395 Main Street

Card access upgrade project

Door modification schedule

Revision 3

Appendix 1. Access Ability The Ingress'r Column Touch Activator

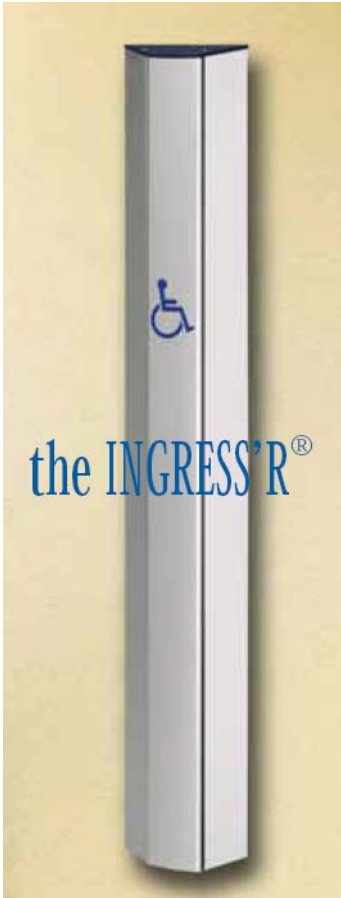
- Install a Wikk Access Ability's The Ingress'r bollard (Appendix 1) (dark bronze finish) at the location specified in Appendix 2
- Mount a Wikk Access Ability's 36" The Ingress'r Column Touch Actuator (dark bronze finish) (Appendix 1) and an Indala Wallswitch card scanner model #FP4521A-10200 (Appendix 3) on the bollard. If cables for the actuator button and the card reader cannot be connected from underneath, surface mounted EMT tubing should be finished with dark bronze paint
- Remove the existing wall mounted actuator (Appendix 2) and cover the mounting box with a 6" bronze round cover plate

- Install a Wikk Access Ability's The Ingress'r bollard (Appendix 1) (dark bronze finish) at the location specified in Appendix 11
- Mount a Wikk Access Ability's 36" The Ingress'r Column Touch Actuator (dark bronze finish) (Appendix 1) and an Indala Wallswitch card scanner model #FP4521A-10200 (Appendix 3) on the bollard. If cables for the actuator button and the card reader cannot be connected from underneath, enclose the cables in EMT tubing finished with dark bronze paint or a matching colour wiremold.

- Install a Wikk Access Ability's The Ingress'r bollard (Appendix 1) (dark bronze finish) at the location specified in Appendix 19
- Mount a Wikk Access Ability's 36" The Ingress'r Column Touch Actuator (dark bronze finish) (Appendix 1) and an Indala Wallswitch card scanner model #FP4521A-10200 (Appendix 3) on the bollard. If cables for the actuator button and the card reader cannot be connected from underneath, surface mounted EMT tubing should be finished with dark bronze paint
- Remove the existing wall mounted actuator (Appendix 19) and cover the mounting box with a 6" bronze round cover plate

- Remove the existing wall mounted wireless actuator (Appendix 21)
- Mount a Wikk Access Ability's 36" The Ingress'r Column Touch wireless actuator (dark bronze finish) (Appendix 1) flush to the wall

Appendix 6. Exterior door (Node 1.02) Von Duprin 3327A exit device

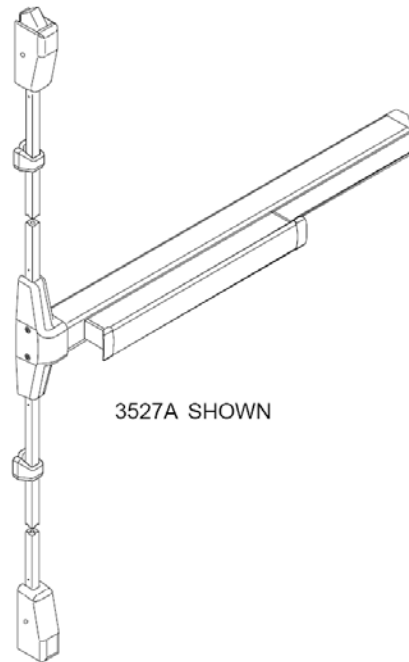
- Remove two existing exit devices and 12" extension rods (Appendix 4 – framed in red)
- Reinstall outer pulls to match height, patch the holes (Appendix 5)
- Install Von Duprin 3327A Exit devices and 12" extension rods (dark bronze finish) (Appendix 6). Both exit devices will have QEL electric motors inside them and be controlled by card access. The south panel of the door will have key override functionality.
- Install Locknetics 788 12" wire transfer armoured door cords (dark bronze finish) (Appendix 7)
- Install a Blank M/S Filler Plate – 613 (brown finish) to cover the door edge opening (Appendix 8)

Appendix 22. Nodes Locations Reference

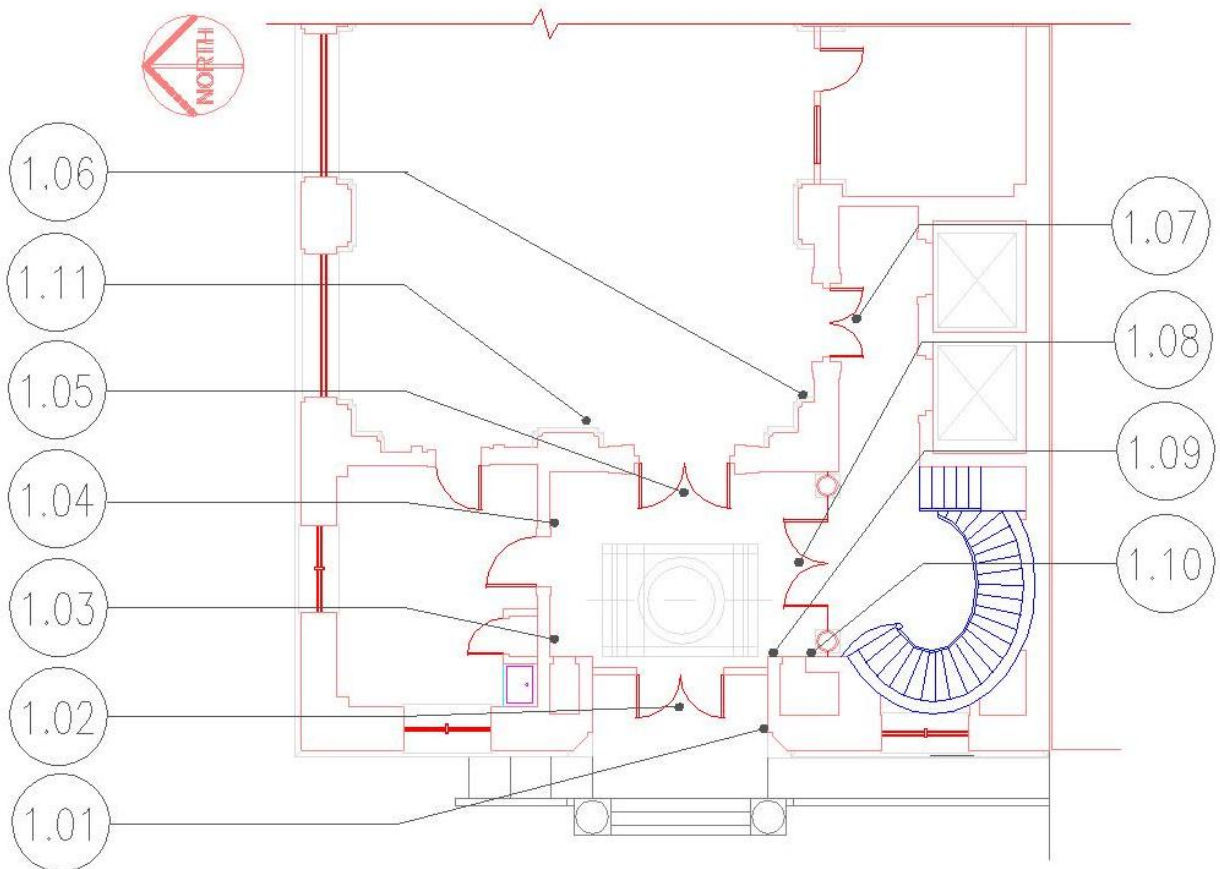
The following changes are planned for the heritage program protected doors on the main floor of the Confederation Building, 395 Main Street. Door location references are shown in Appendix 22
